Muazuddin Textile Limited (New Unit)

235/236 East Chandura, Shafipur, P.S. Kaliakore, Gazipur
(24.034397N,90.271276E)
21st May 2018

Observations

Column Layout

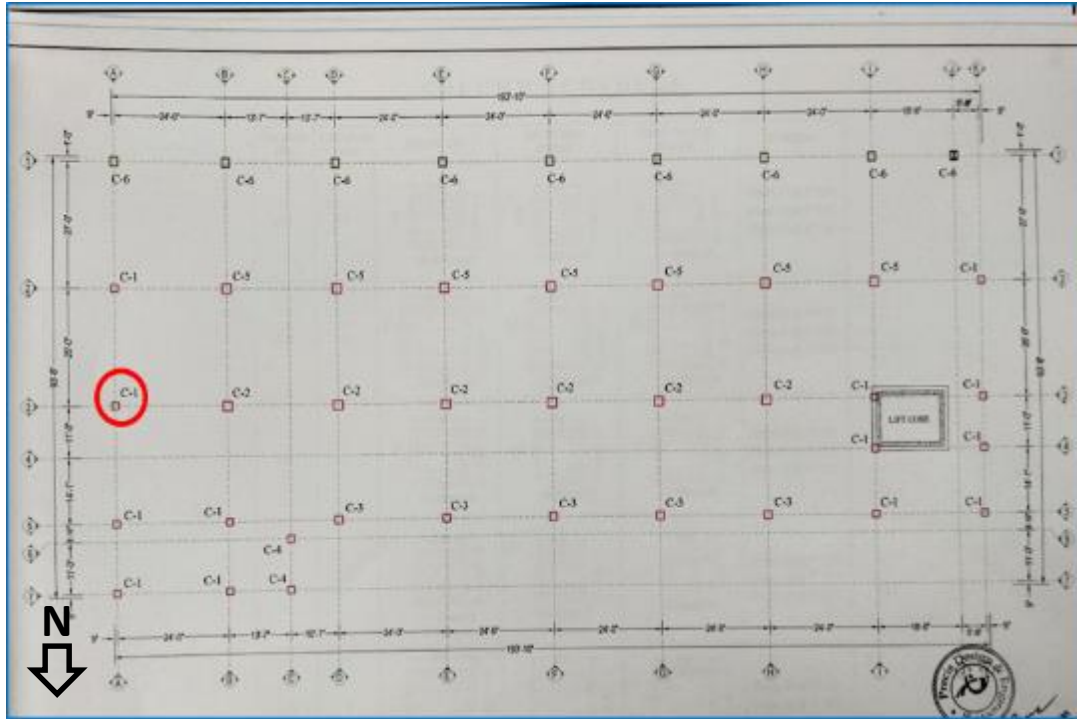
**Columns appeared to be stressed above
normal design limit**

Cursory calculation indicates that highlighted column appear to be stressed above normal design limit due to brick wall & build-up of toilet area. Factory engineer need to check column stress and should take necessary action according to report.

Bolted connection between RC column and steel beam

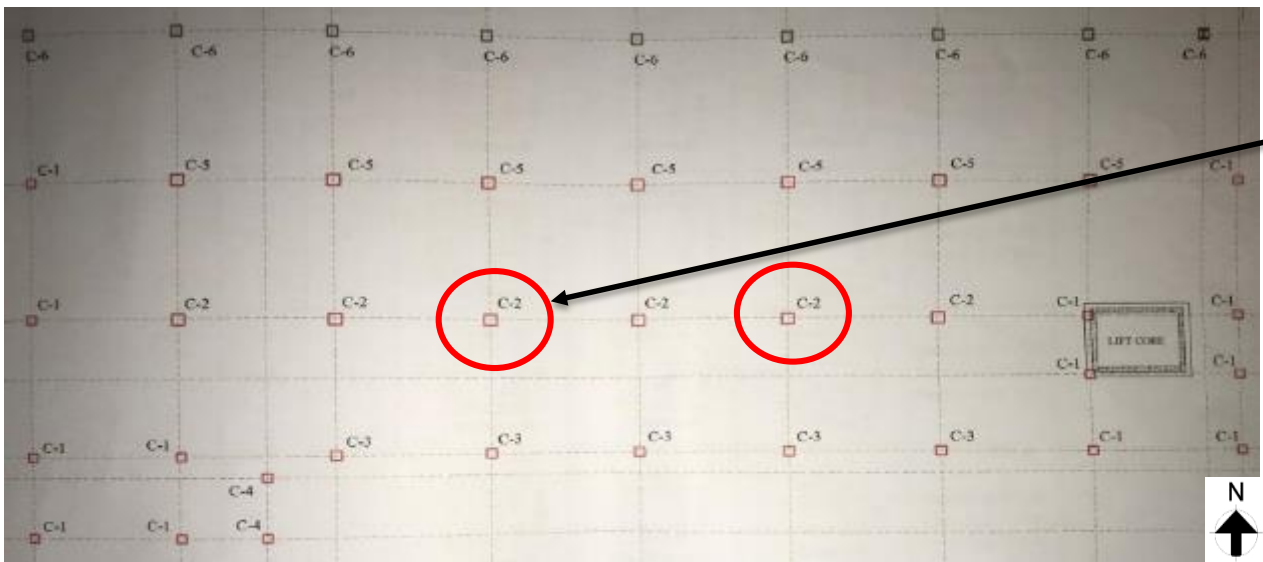
Connection between steel and reinforced part is required to be evaluated

Steel part is found connected by bolt with RC part. The factory is required to engage an engineer to evaluate the connection between two part.

C-2 type column

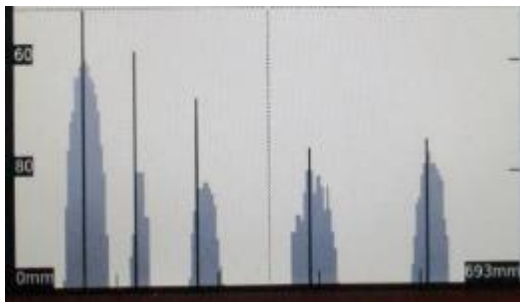
18 number of rebars were found by ferro scanning in C-2 type column

Column Layout Plan

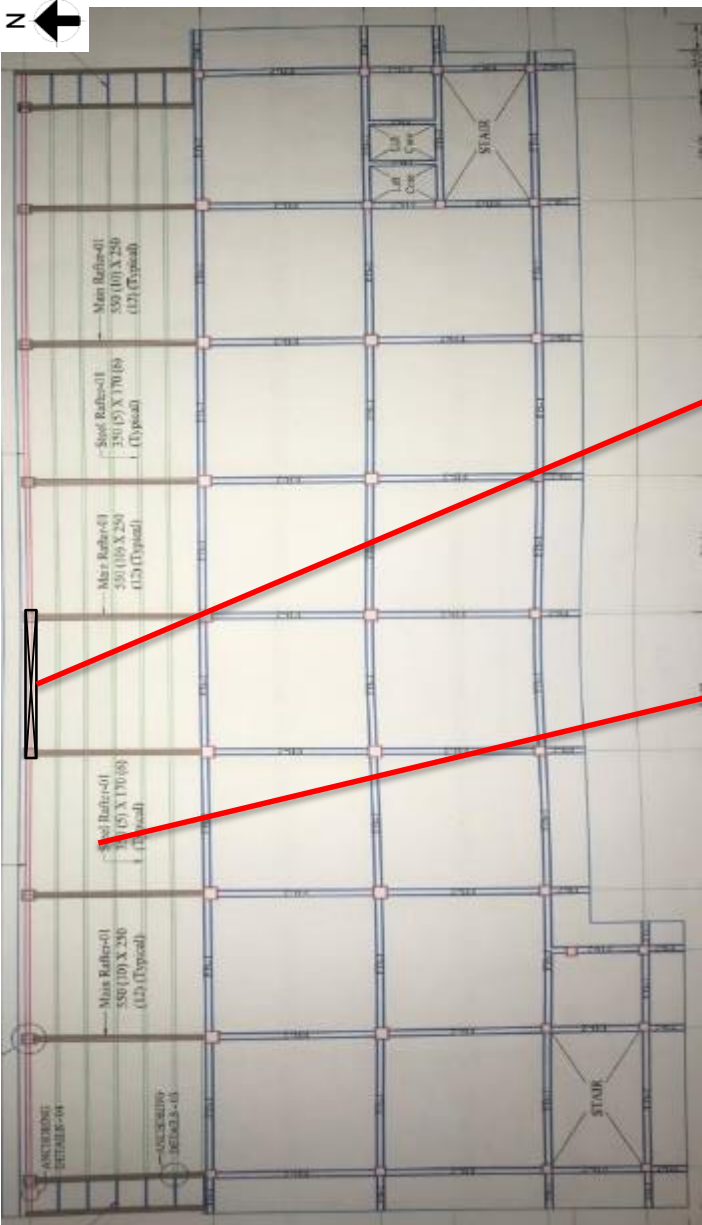
22 number of rebars were shown in column schedule for C-2 type column in 1st to top floor

22 number of rebars were shown on the drawing in C-2 type column but during inspection 18 number of rebars were found by ferro scanning in 1st floor.

Water clogging on roof top

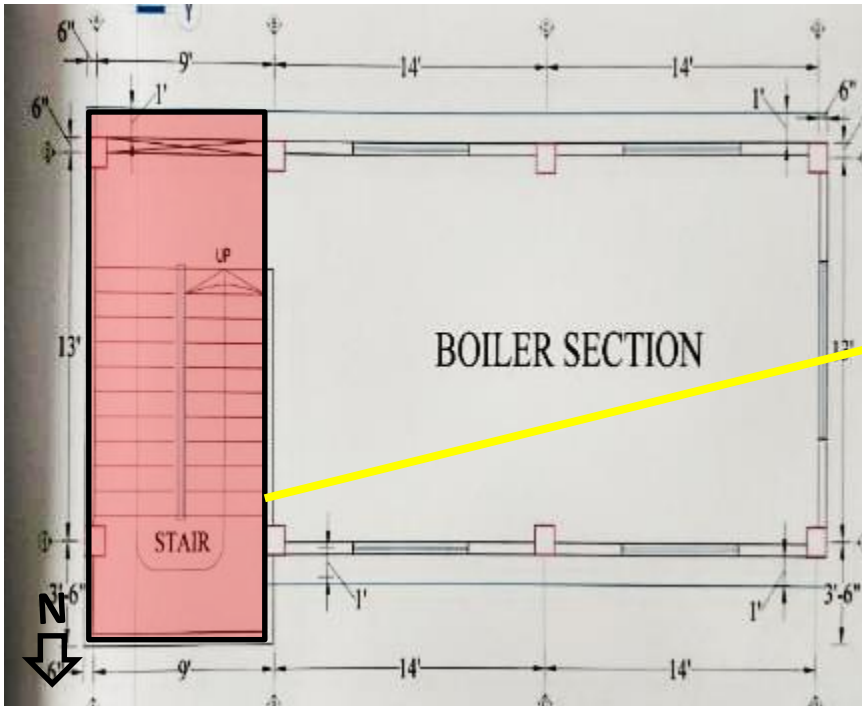
During inspection, water clogging was observed on roof top. Factory is required to improve the water drainage system to prevent the water clogging.
